7 INSTRUMENTATION AND CONTROLS

This chapter presents the U.S. Nuclear Regulatory Commission (NRC or Commission) staff's (herein after referred to as the staff) review of the instrumentation and controls (I&C) for the NuScale Power, LLC (NuScale), small modular reactor (SMR) nuclear power reactor design certification application (DCA), Revision 2. This is part of the design certification review conducted by the NRC staff under Title 10 of the *Code of Federal Regulations* (10 CFR) Part 52, "Licenses, Certifications, and Approvals for Nuclear Power Plants." The description of the I&C systems includes the overall design bases, system classifications, functional requirements¹, and system architecture, which encompasses all I&C systems and components (i.e., hardware, software, firmware, and other forms of complex logic) and areas such as software tools and equipment that are used for the I&C design or are connected to the I&C systems or components for testing.

Figure 7.2.7-1: Setpoint relationships during surveillance testing and calibration⁴

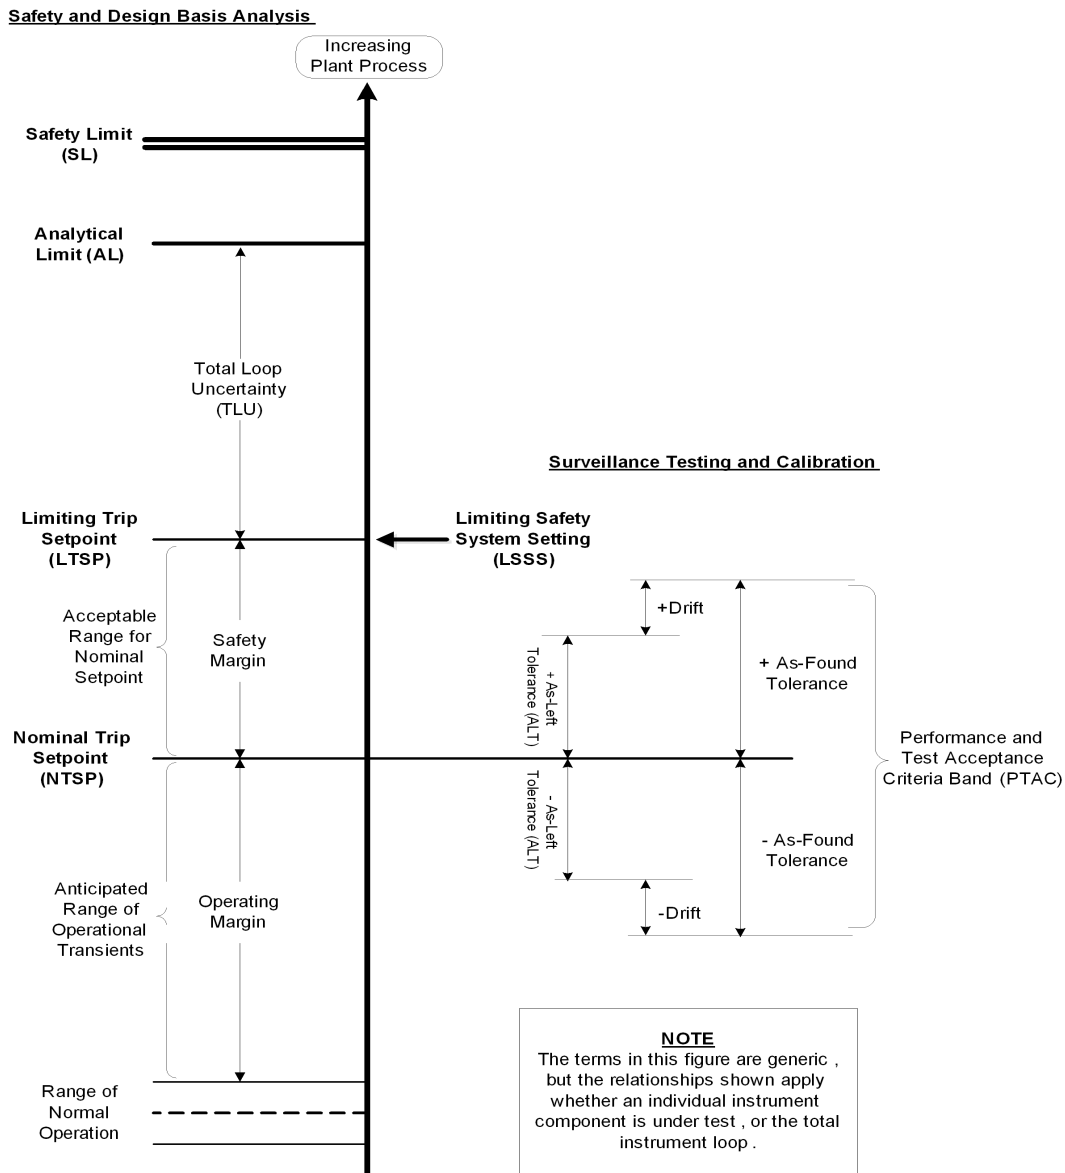
In the NuScale methodology, the AL is established to assure that a trip occurs before the SL is reached. The purpose of an LSSS is to assure that a protective action is initiated before the

process conditions reach the AL. NTSPs are chosen based on the LSSS and to minimize spurious trips close to the normal operating point of the process. Figure 7.2.7-1 below provides a pictorial representation of the NuScale setpoint methodology relationships.

This figure is intended to provide relative position and not to imply direction. Sections 4.1.3 and 4.1.4 in TeR-0616-49121 define LTSP as an LSSS and also define NTSP as the desired value of the measured variable at which an actuation occurs. The calculation of the LTSP value is given in TeR-0616-49121, Section 4.2, Equation 4-1, as $LTSP = AL \pm TLU$, where TLU is the total channel uncertainty.
